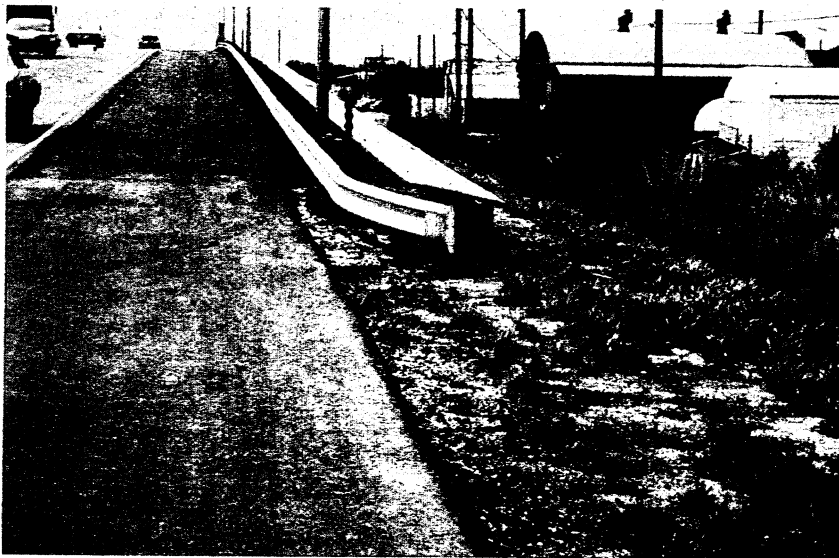
Moving along to the actual application, you see this rather abruptly curved transition into a guardrail section. This is in advance of a slope condition.

Mr. PRISK. This appears to be an extremely short flare, and the treatment here certainly is a rather abrupt flare and is not buried, as you can see.

Mr. CONSTANDY. I notice that there is one post on the end, and by the next post the guardrail is back on a tangent, so the length of that flare is generally 12 feet.

Mr. PRISK. I think that it should be. This is a very abrupt flare, for one thing, and the end of the post, the end of the rail was exposed to traffic at a rather close point as far as the shoulder is concerned, only 3 or 4 feet away.

Mr. CLAUSEN. My immediate reaction, again as a layman, is that it offers no protection. If a person were to skid off and hit that rail there, certainly there would be no deflecting tendencies on the part of what you have there.

Mr. CONSTANDY. In addition, as Mr. Prisk pointed out, these particular installations do not have a blocked-out section. Neither do they have in all cases—am I correct, Mr. Prisk, they do not always have washers?

Mr. CONSTANDY. I think, Congressman, the slides taken on the new contiguous project would suggest they think so, too; because on the new work, they have increased the degree of the offset from the end post to the shoulder, and so, in effect, have increased the flare.
